BUILYEON ROAD - ZEBRA CROSSINGS

Report Title:	Builyeon Road - Zebra Crossing Stage 1 Road Safety Audit
Date:	January 2026
Document Reference and Revision:	2526_204
Prepared by:	AtkinsRéalisis
Overseeing Organisation:	City of Edinburgh Council

AtkinsRéalisis has been commissioned by City of Edinburgh Council (CEC) to undertake a Stage 1 Road Safety Audit (RSA) on the proposed Zebra crossing facilities at Builyeon Road in South Queensferry. This report documents the outcome of the RSA in the form of identified road safety problems and associated recommendations.

Problem:	3.1
Location(s):	Both zebra crossings
Drawing(s):	RS<I/BRZC(east)/GM01 and RS<I/BRZC(west)/GM03
Summary:	Proximity of bus stops to zebra crossings may contribute to pedestrian collisions

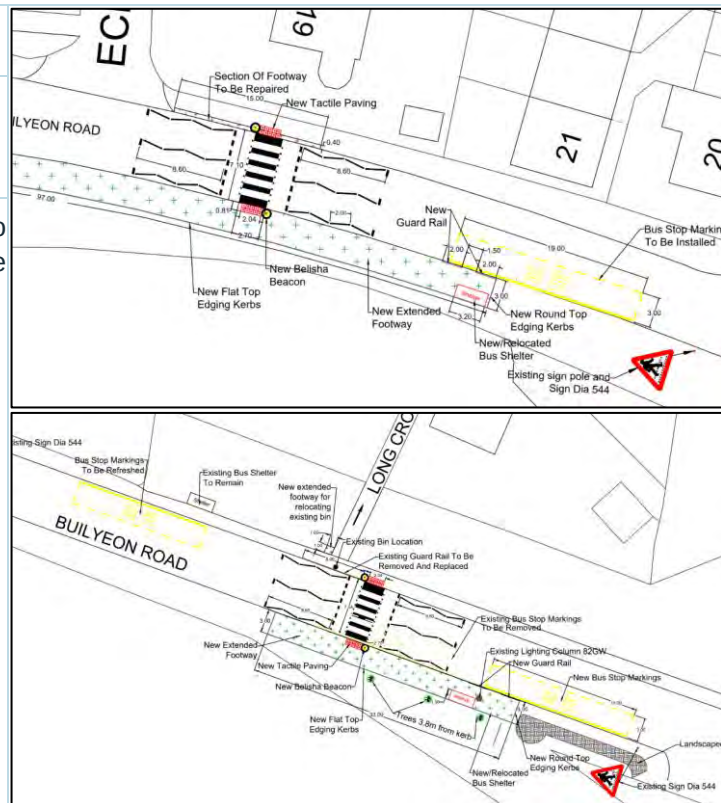
Within the proposals, bus stops have been placed in close proximity to both zebra crossings, one on the westbound approach to the western crossing and on both approaches to the eastern crossing. While a bus is serving these stops, intervisibility between pedestrians at the crossing and approaching drivers may be obstructed. In addition to this, vehicles may also be in the process of overtaking the stationary bus and returning to their own side of the carriageway. A combination of the above may mean that a driver is unaware of the pedestrian trying to assert priority at the crossing, potentially contributing to a collision between a crossing pedestrian and a vehicle.

It is recommended that the bus stops are relocated away from the zebra crossings to ensure that there is suitable intervisibility between approaching drivers and users of the crossings.

Problem: 3.2

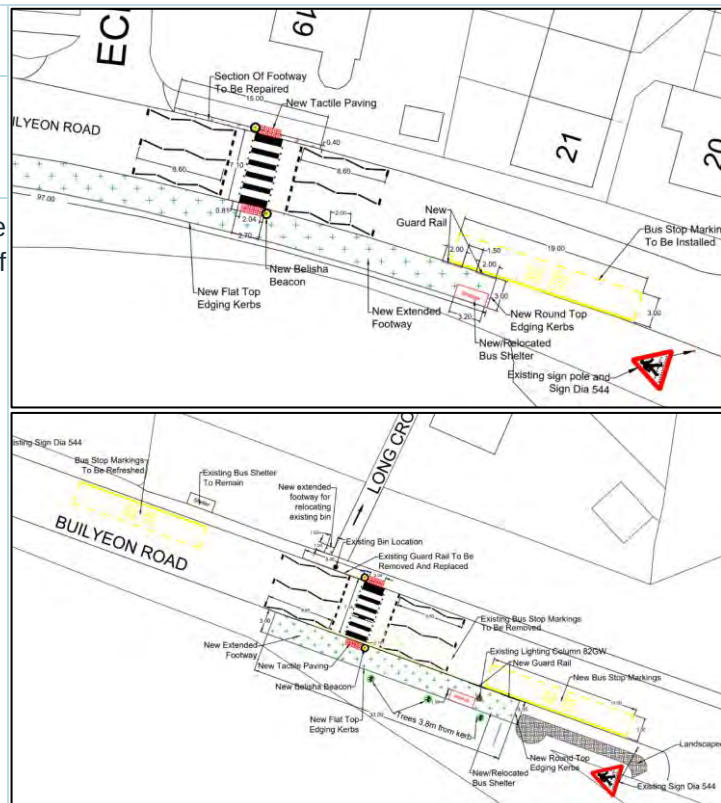
Summary: Speeds may contribute to poor compliance with the Zebra crossings

During the site visit it was observed that several vehicles appeared to be travelling in excess of the 30mph speed limit. Motorists approaching at speeds may struggle to stop for a pedestrian on or waiting to cross, this could result in them overshooting the giveway line and colliding with crossing pedestrians. It is noted that the plans indicate the installation of a Vehicle Activated Sign (VAS) however, it is unclear what purpose this will serve.

It is recommended that features are provided to reduce / manage vehicle speeds, this may include high PSV surfacing on approach to the crossing.

Problem: 3.3

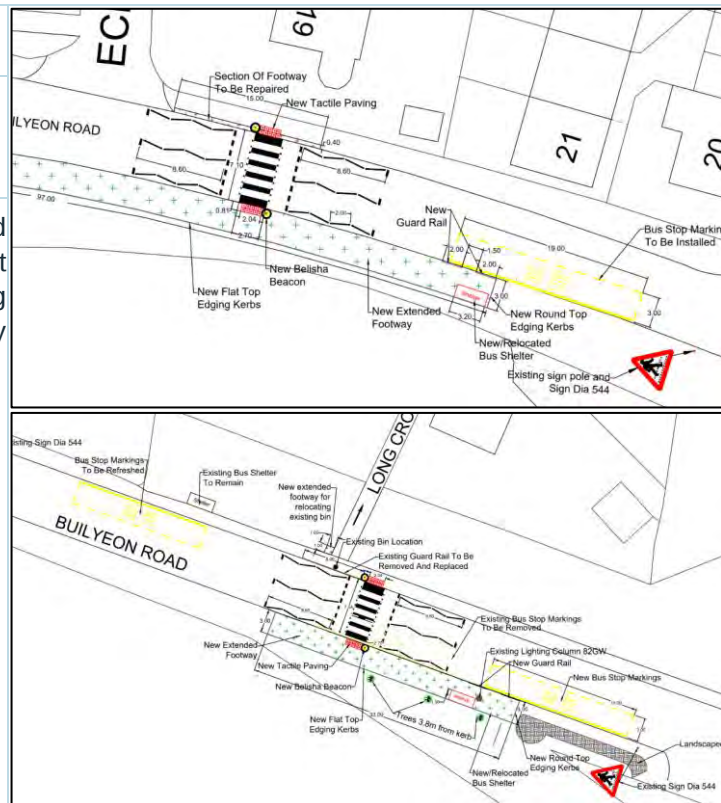
Summary: Zebra crossing may not be suitable for the speed of traffic.

During the site visit it was observed that several vehicles appeared to be travelling in excess of the 30mph speed limit. Builyeon Road is a straight traffic distributor road with minimal direct frontages. The psychology of a driver may feel that they can travel faster on a road of this nature. There is a risk that speeds may be higher than appropriate for a road with zebra crossing installations. This could result in speed related collisions, either resulting from sudden braking or skidding.

It is recommended that a speed survey is undertaken to confirm if the 85th percentile speed of the road is appropriate for the installation of zebra crossing. If speed is excessive, it is recommended that additional measures are implemented to reduce the speed of traffic on the road.

Appendix B. Location of Problems

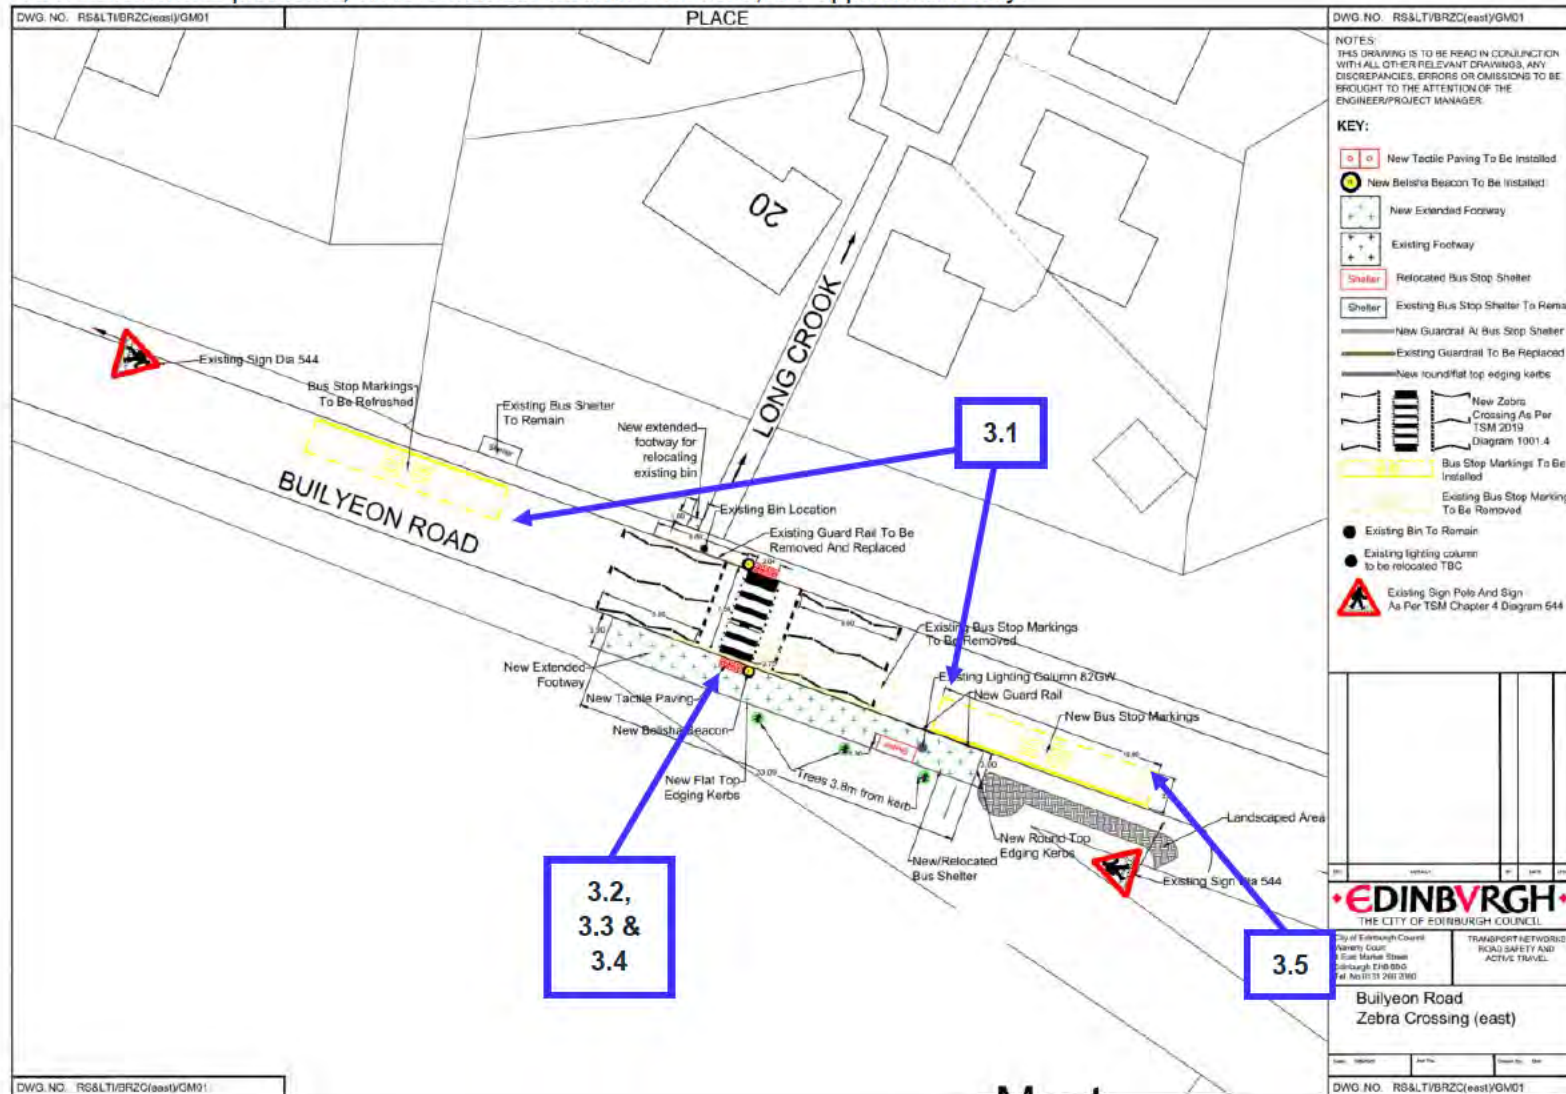
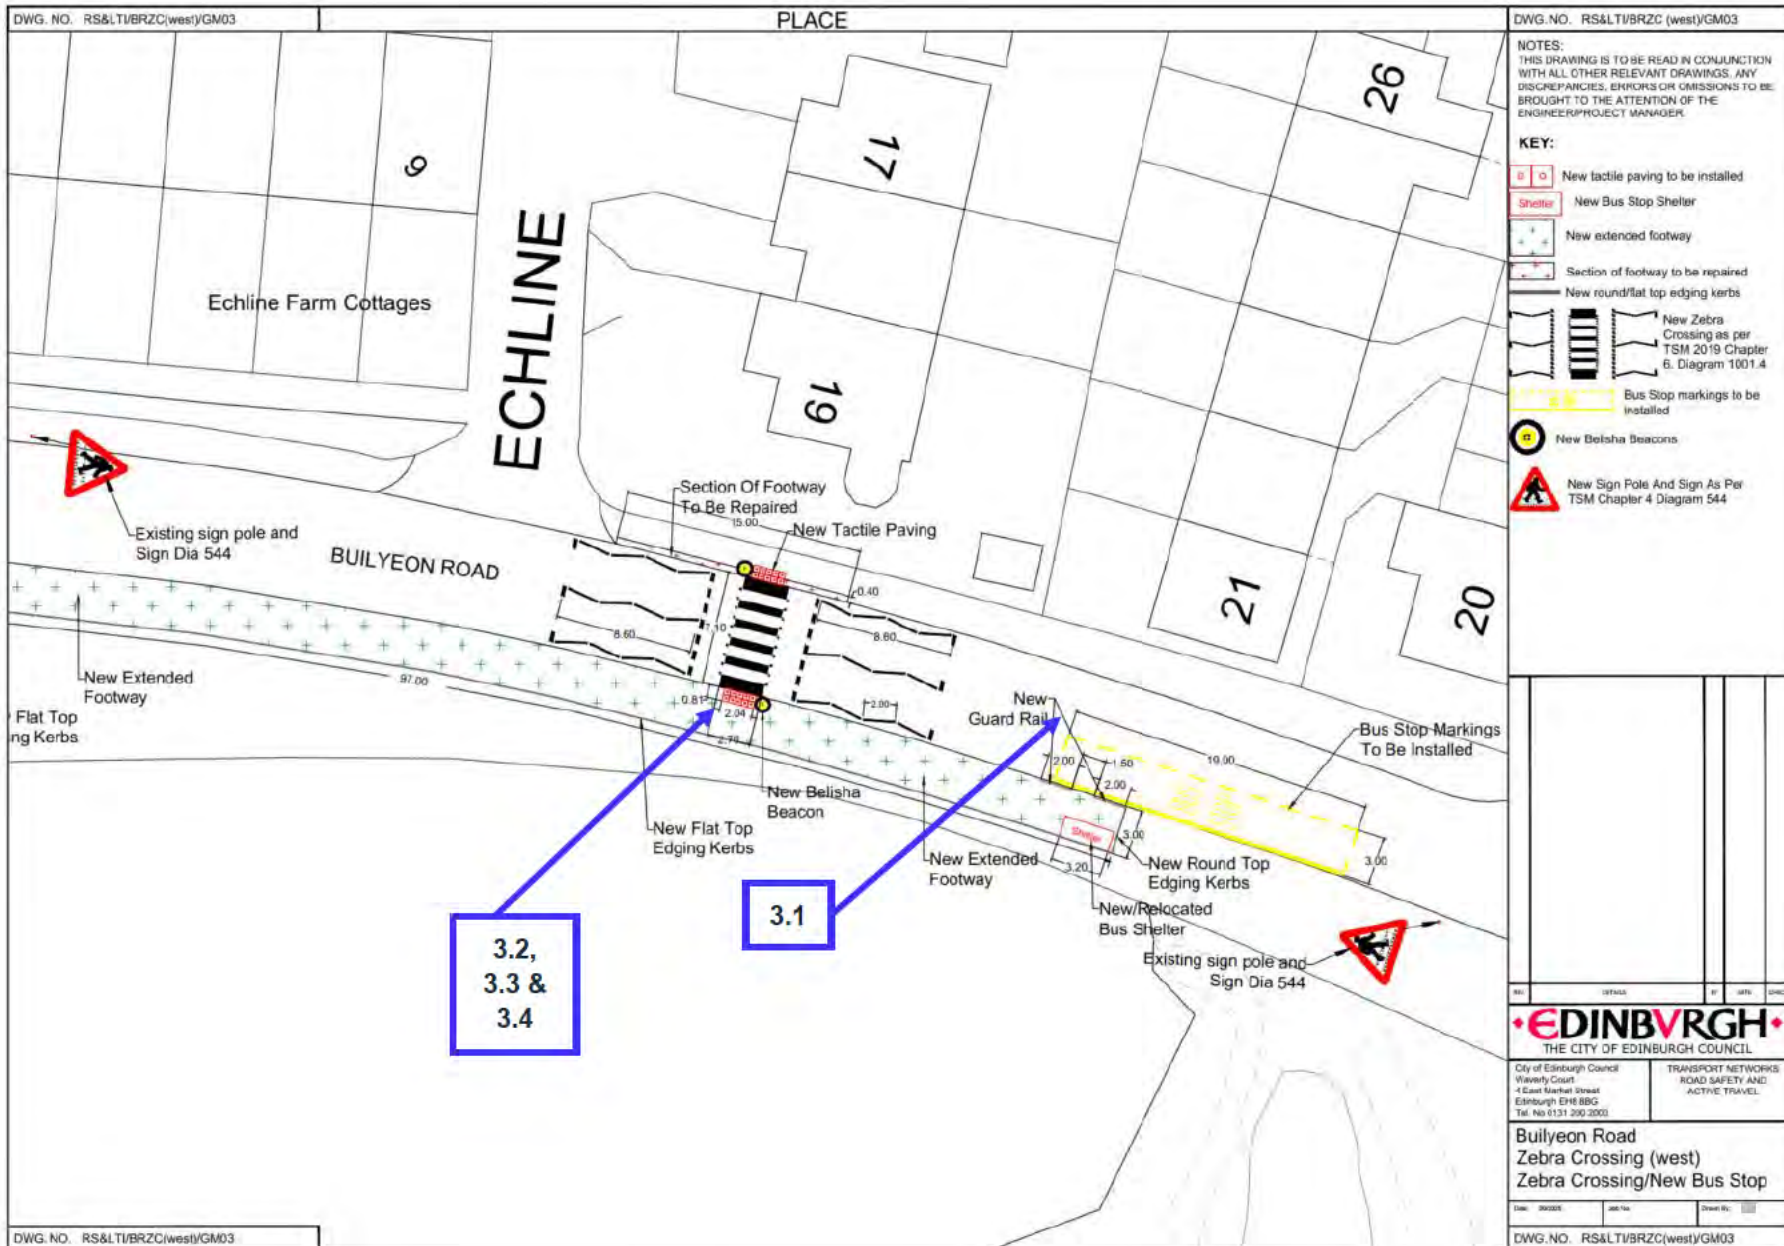
Within the proposals, the arrangement of the proposed tactile paving does not help visually impaired users to identify that this is a controlled crossing. Additionally, it is not clear if the kerbs, upstands or gradients make this crossing accessible for all users. If the crossing is not accessible or identifiable then vulnerable road users may attempt to cross elsewhere and may be struck by vehicles.

It is recommended that the tactile paving layout, kerbs and gradients related to the zebra crossings are altered to help make these crossings more accessible to all users.
